Info Only: Comments from Service Engineering and Stormwater Engineering are in blue text.

Flying Horse North Filing No. 4
Final Drainage Report

September 2024

Culvert 6 (5-Year)

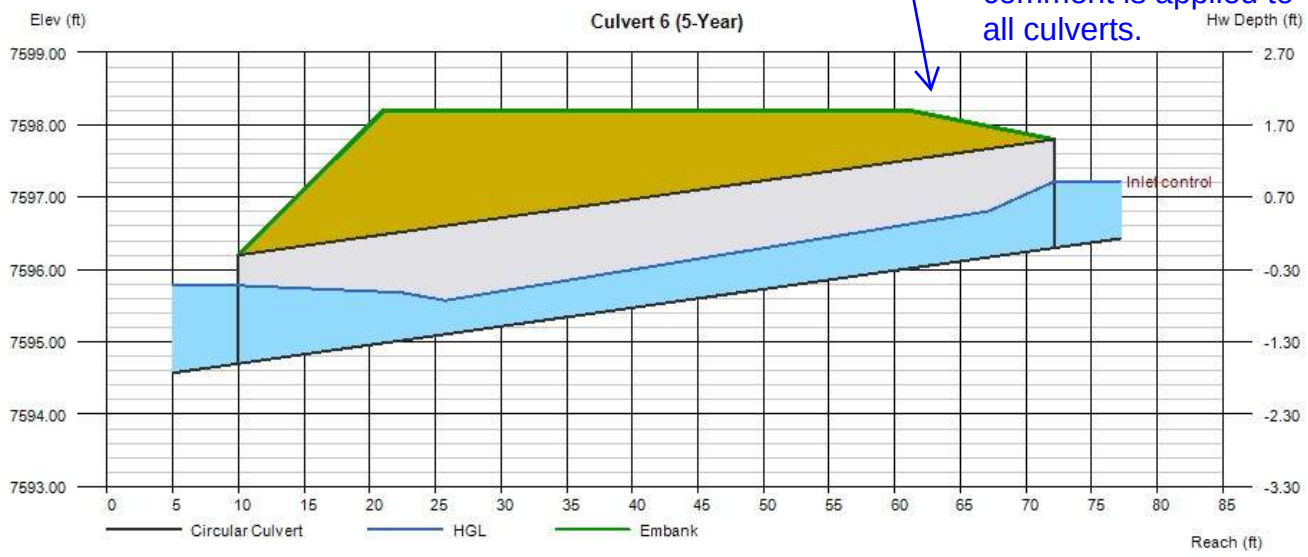
The burial depth must be at least 2 feet for all culverts. Please update the CD accordingly. This comment is applied to all culverts.

Culvert 6 (100-Year)

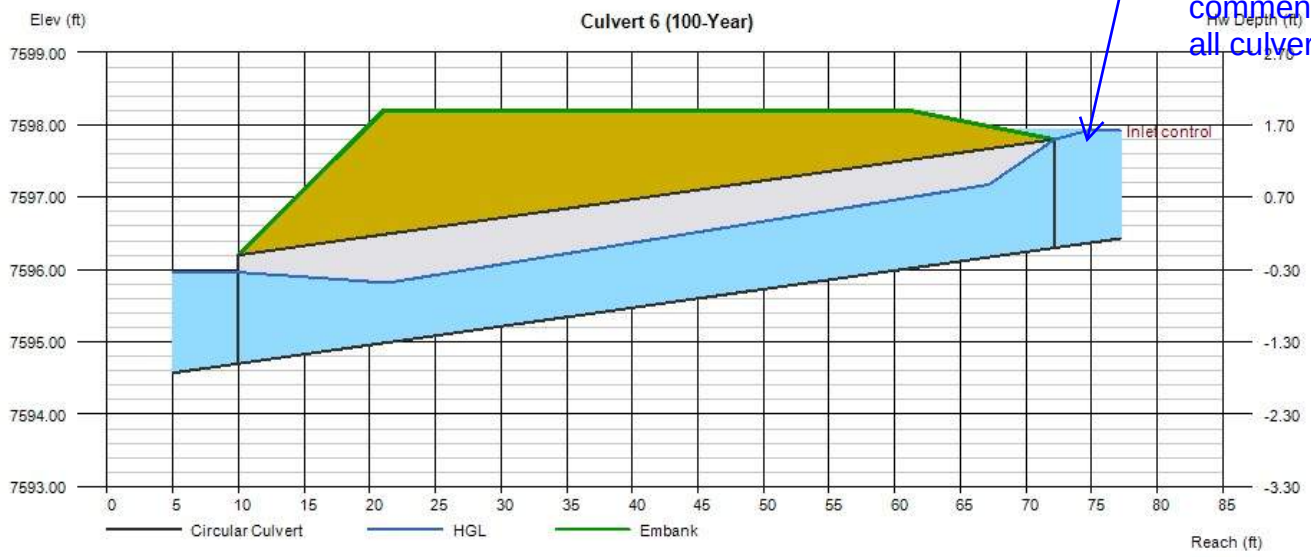
100 yr must be at least 1ft below the ground. This comment is applied to all culverts.

SHEET DR2

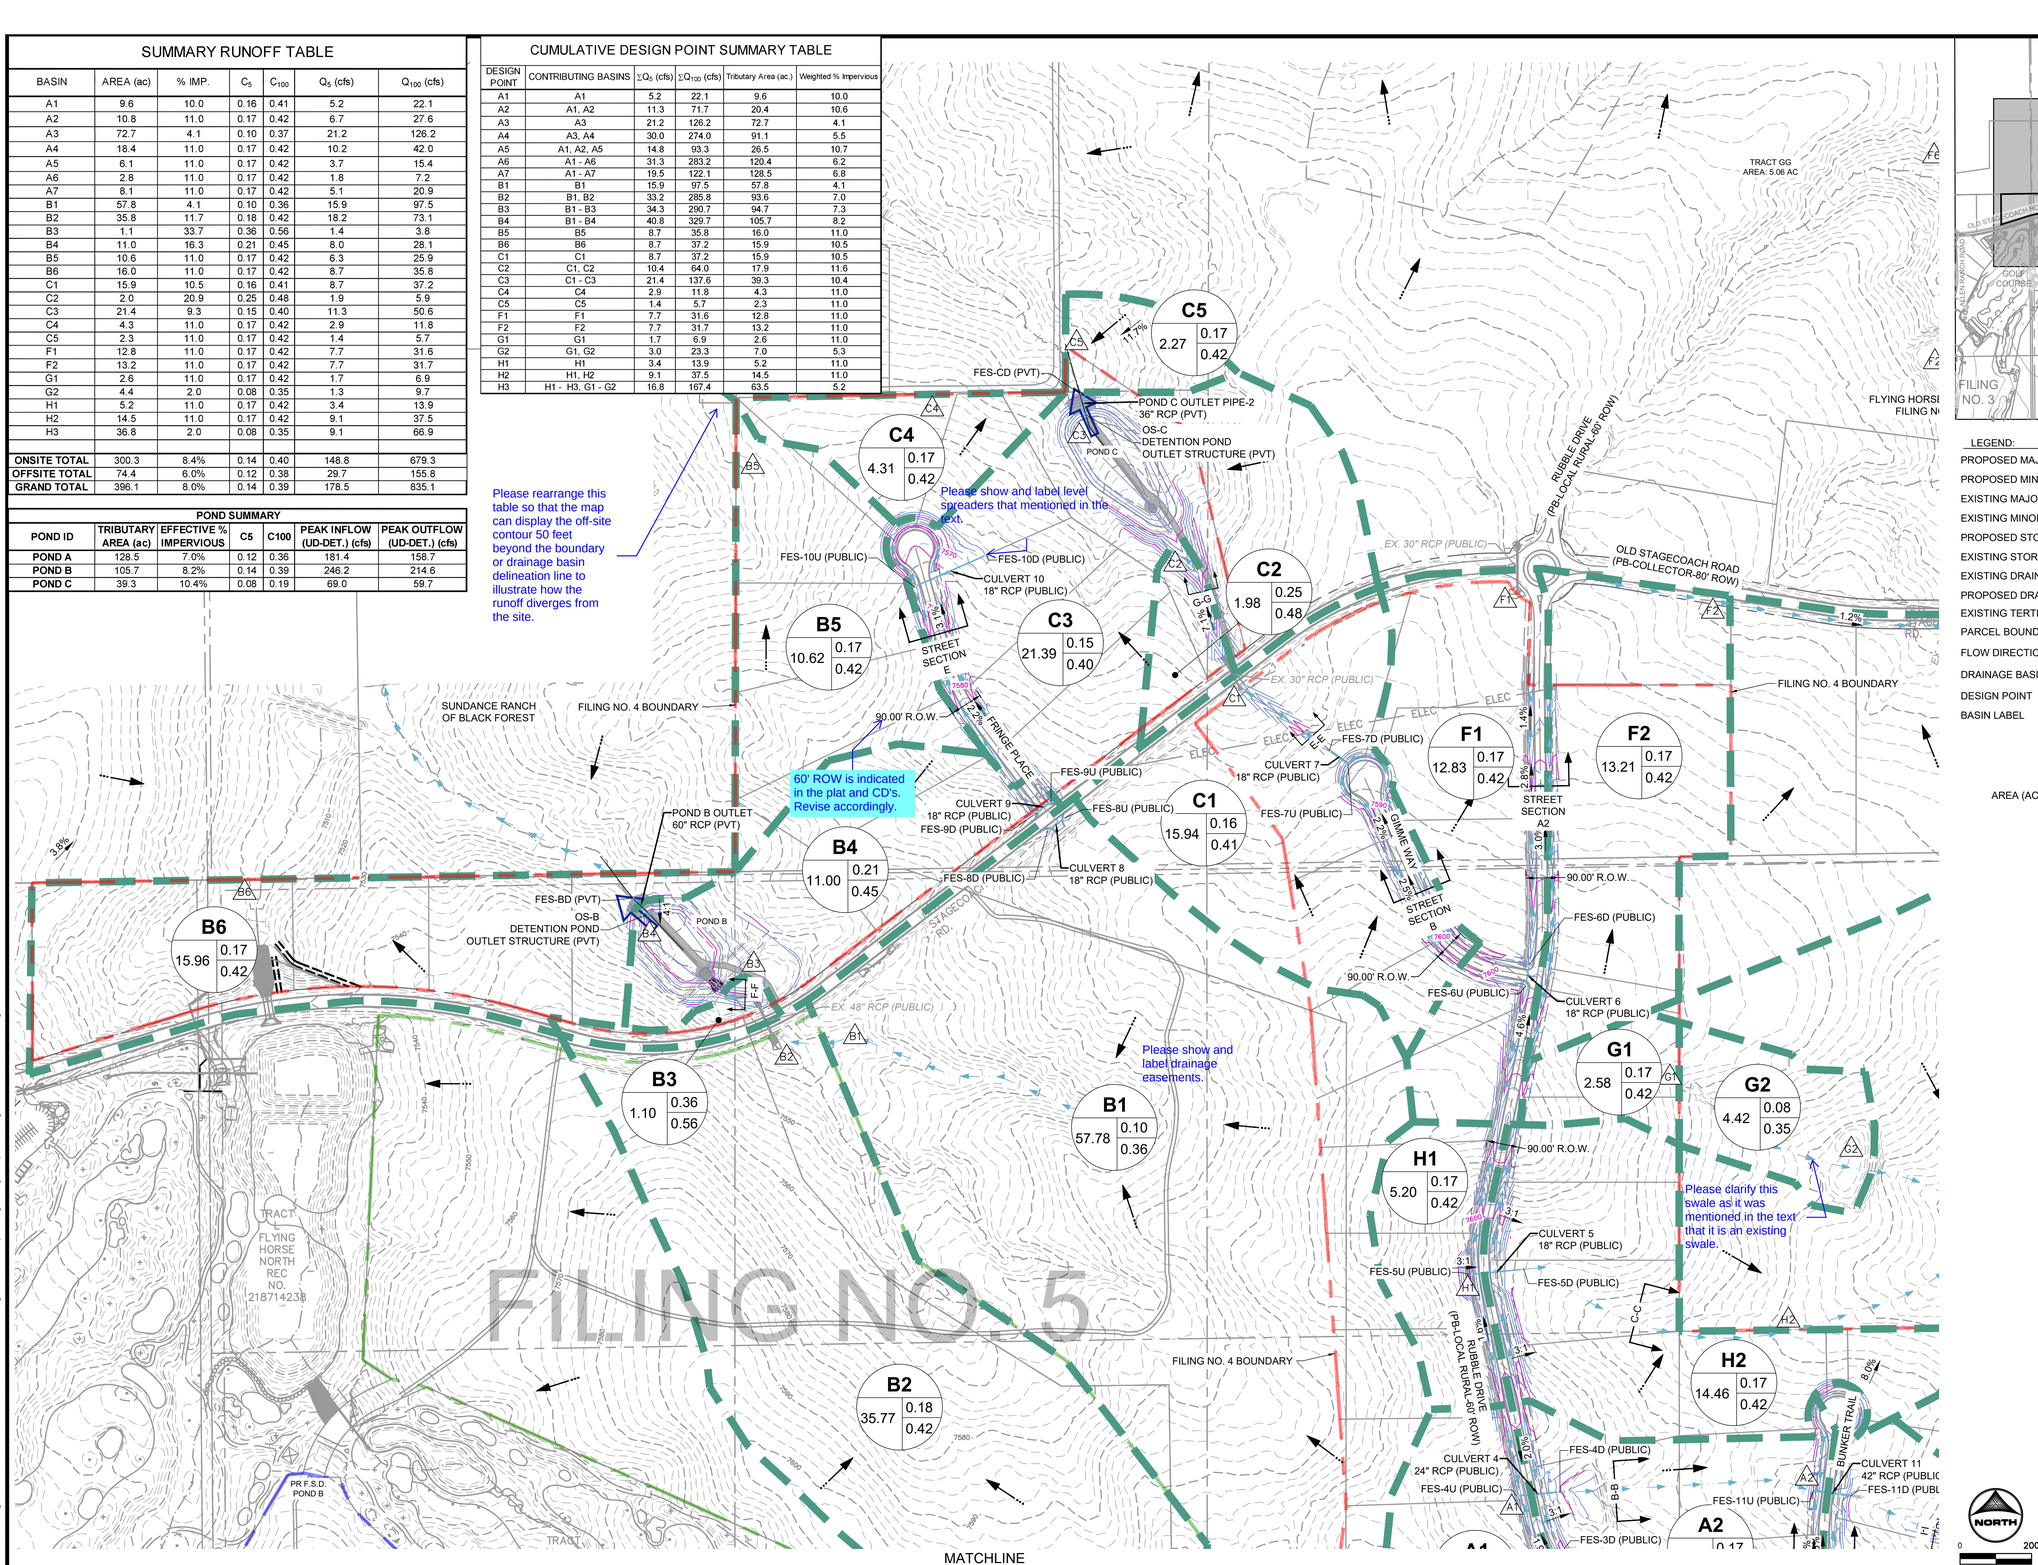
Please clarify this swale as it was mentioned in the text that it is an existing swale.
